SUBJECT: Forwards response to 840814 request for review of proof & review Tech Specs. Function of committee for review & comment on Rev 3 to NUREG-0212 provided. Implementation of encl changes necessary for certification of Tech Specs.

September 14, 1984
ANPP-30516

Subject: PVNGS Units 1, 2, and 3
Proof and Review Technical Specifications
Docket Nos. STN 50-528/529/530
File: 005-419.05

FIGURE 3.1-3
CEA INSERTION LIMITS VS THERMAL POWER
(COLSS IN SERVICE)

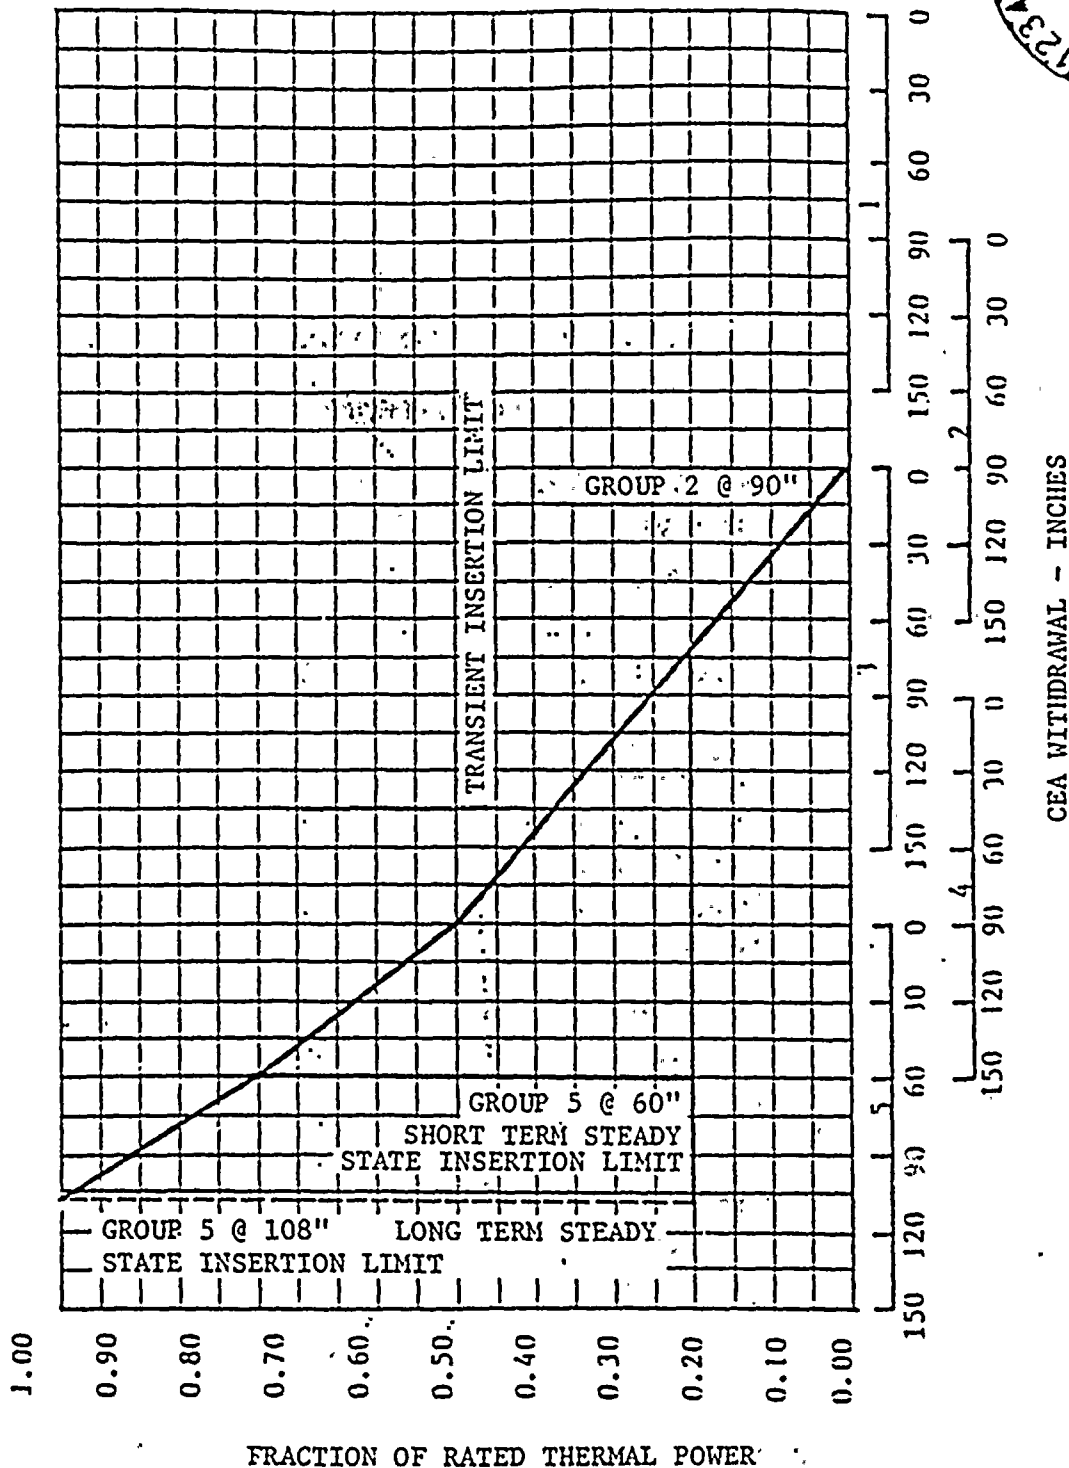
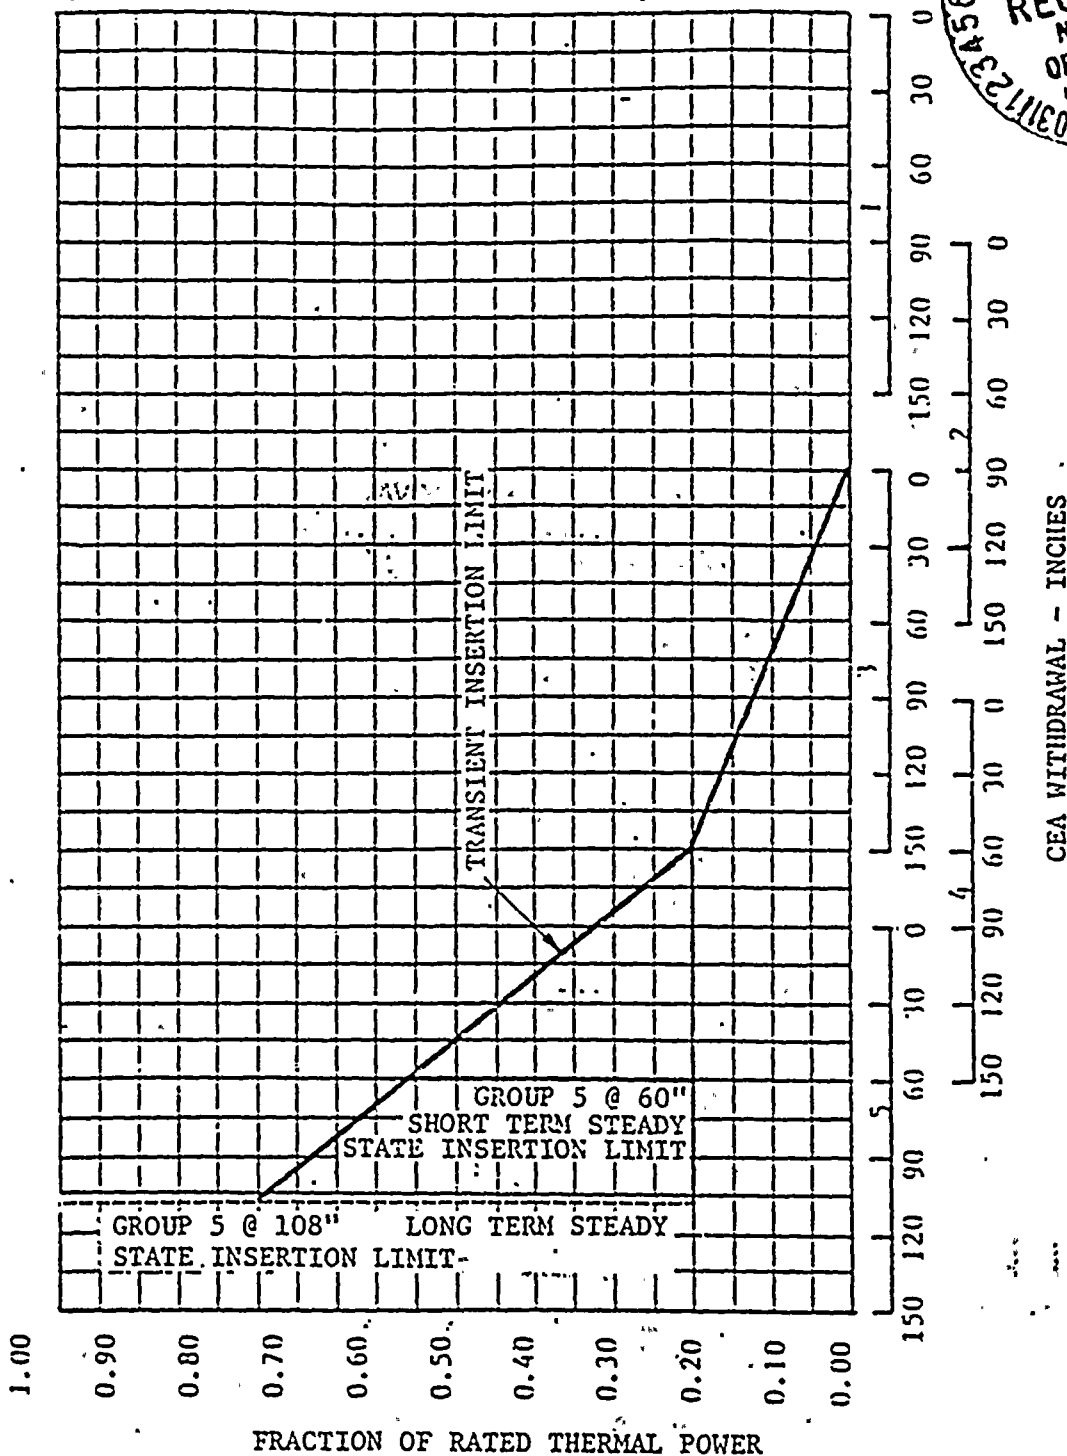
##Following a reactor power cutback in which (1) Regulating Groups 4 and/or 5 OR Reg. are dropped or (2) Regulating Groups 4 and/or 5 are dropped and the remaining Groups 1, 2, 3, and 4 sequentially inserted, the Transient Insertion Limit of Figure 3.1-3 can be exceeded for up to 2 hours. AND 5

OR Figure 3.1-4

FIGURE 6.2-1
OFFSITE ORGANIZATION

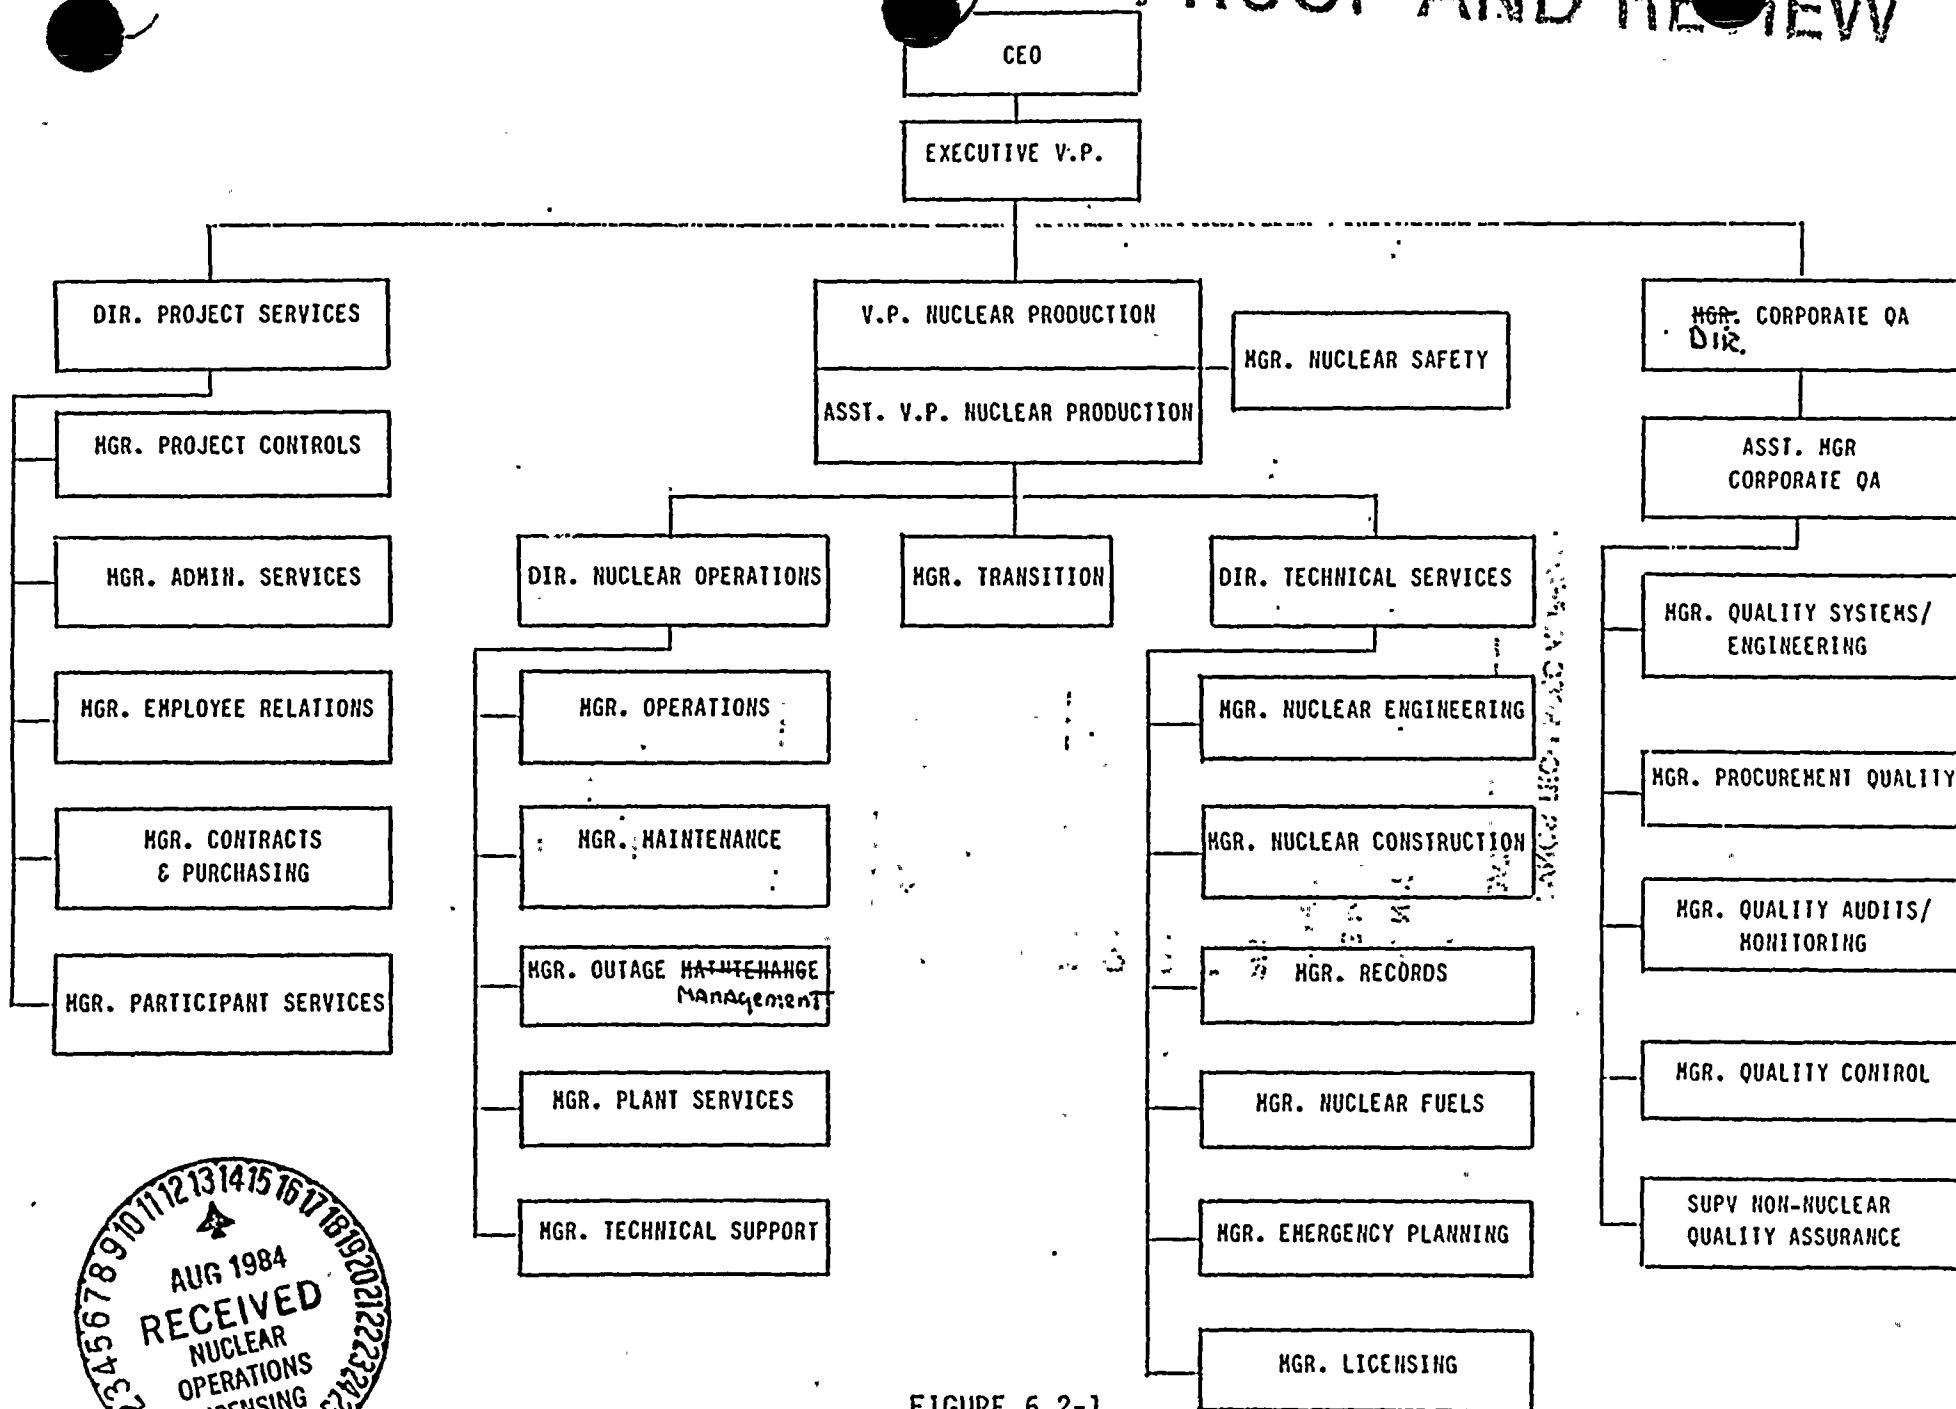
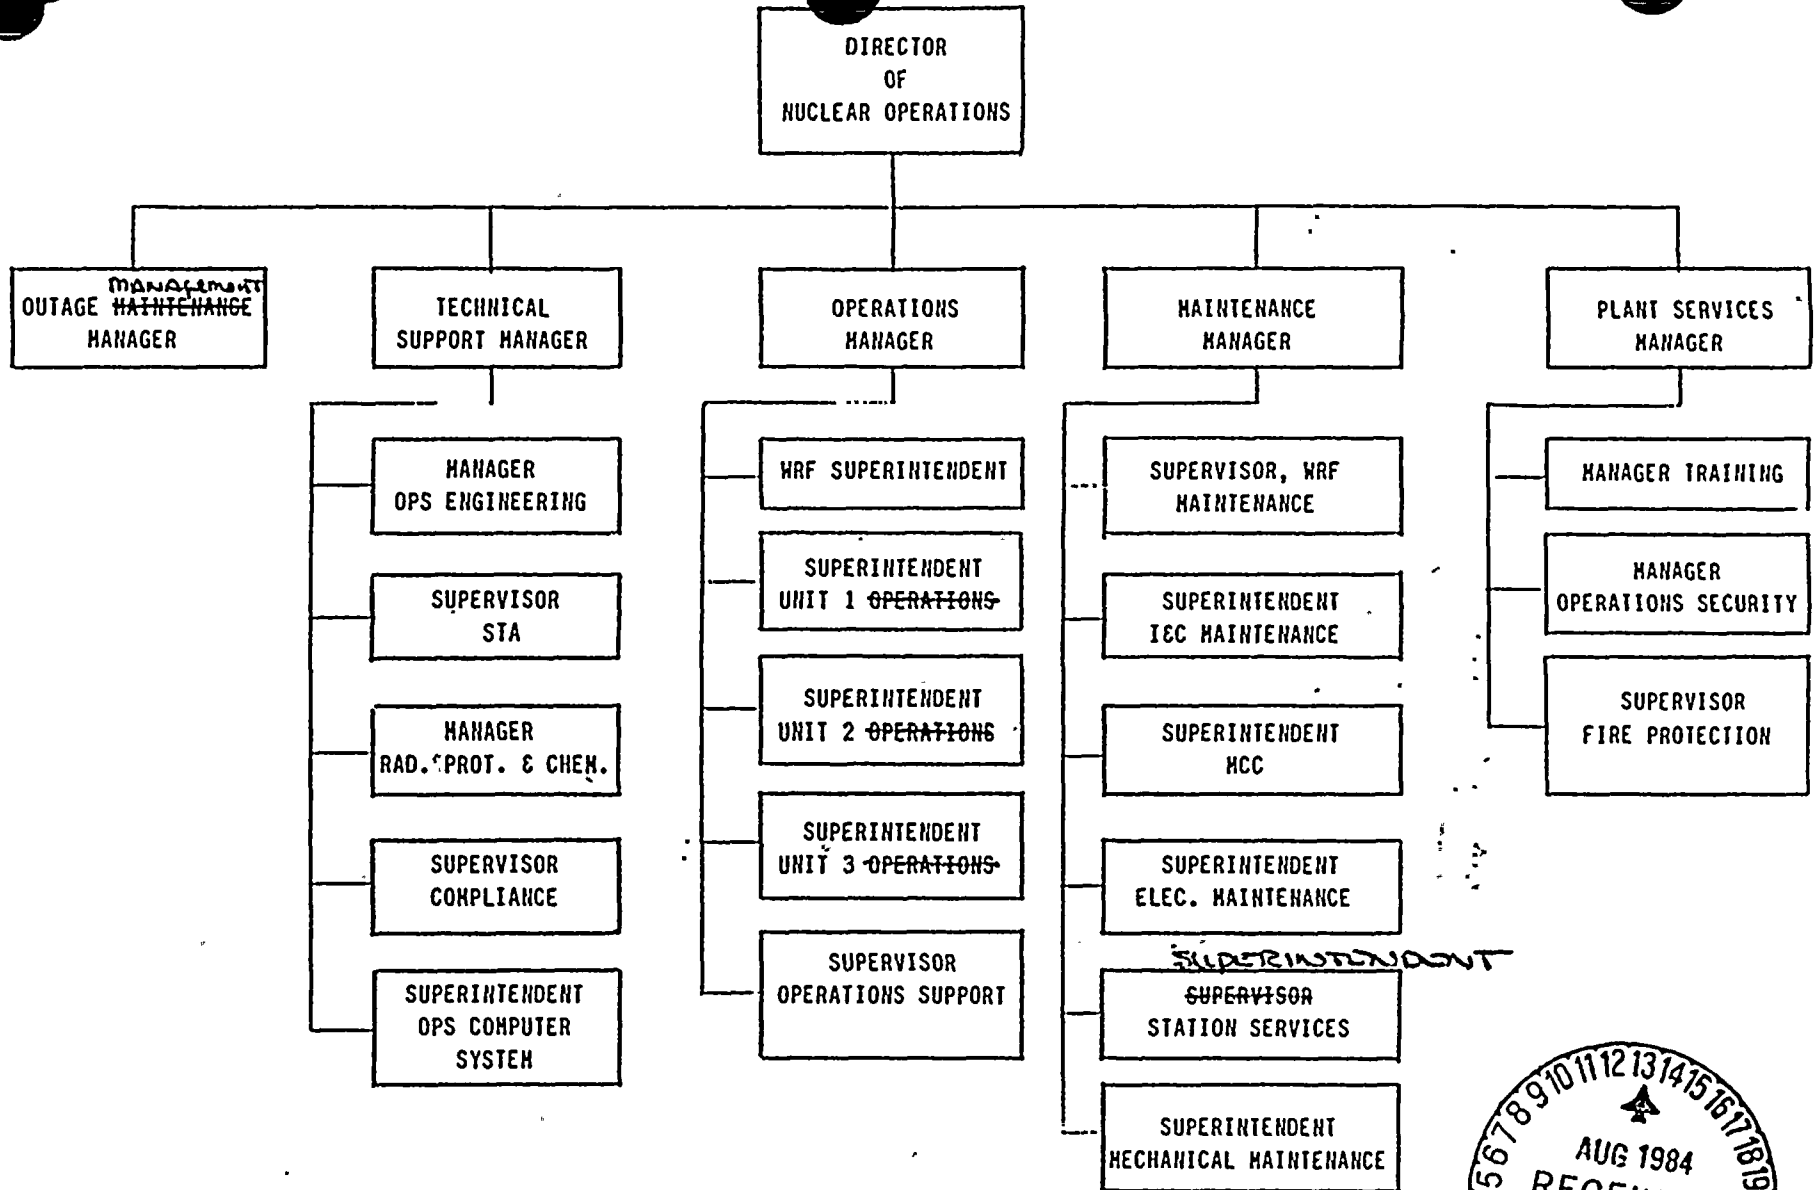
6.2.1 The offsite organization for unit management and technical support shall be as shown in Figure 6.2-1. *OR AS SPECIFIED IN THE FSAR.*

6.2.2.1 The unit organization shall be as shown in Figure 6.2-2 and: *OR AS SPECIFIED IN THE FSAR*
